**NSLPP MEETING HELD ON 01/06/2022**

**ADDRESS/WARD:** 1 Warung Street, McMahons Point

**APPLICATION No:** DA 379/21

**PROPOSAL:** Partial demolition of existing residential flat building, construction of below ground basement and reconstructed and new apartment addition above and configuration of remaining apartments.

**Figure 39: Tree removal and retention plan – trees to be retained (marked in yellow) and trees to be removed (marked in red/black)**

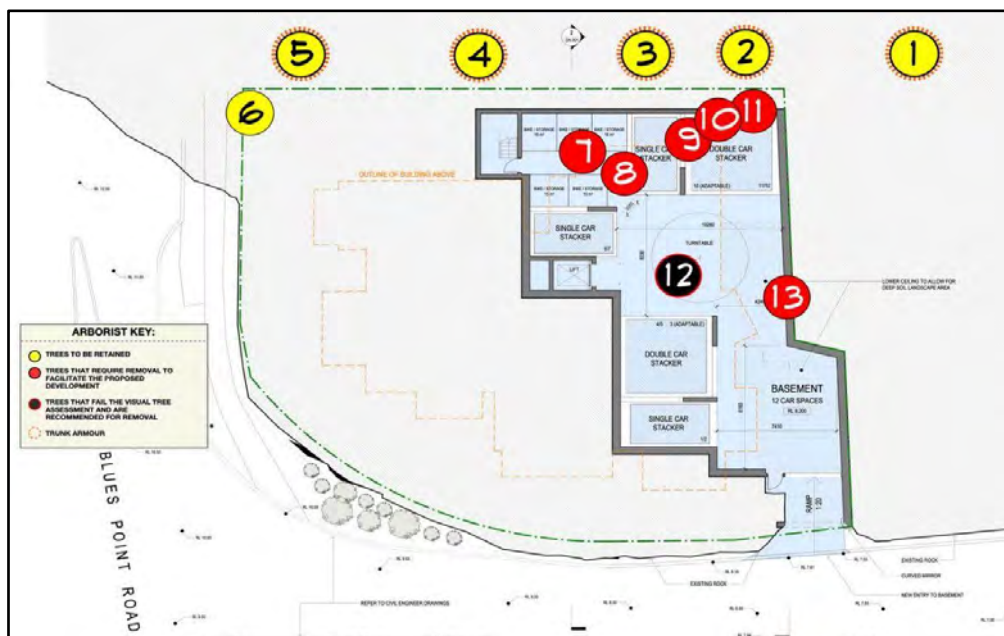
The proposed development involves the removal of seven (7) trees and other plantings (refer to Figure 39). Council’s Landscape Development Officer confirmed support for the removal of these trees and the replacement plantings incorporating several tall and medium-sized trees, shrubs, grasses and groundcover species, palms and tree ferns scattered throughout the site. It is noted that several trailing plants are proposed above the rock wall sections facing Henry Lawson Avenue and Blues Point Road – which further assist in improving the presentation of scheme and integrating the landscaped treatments with the rock wall. With regard to the proposed vegetation removal and landscaping treatments alone the application is able to satisfy the respective aims under Chapter 2 of this SEPP.

*No objection is raised to the removal of T7-T13, subject to the additional planting of 2 x Tristaniopsis laurina (75l) within the rear (southern) setback of No. 1 Warung Street.*
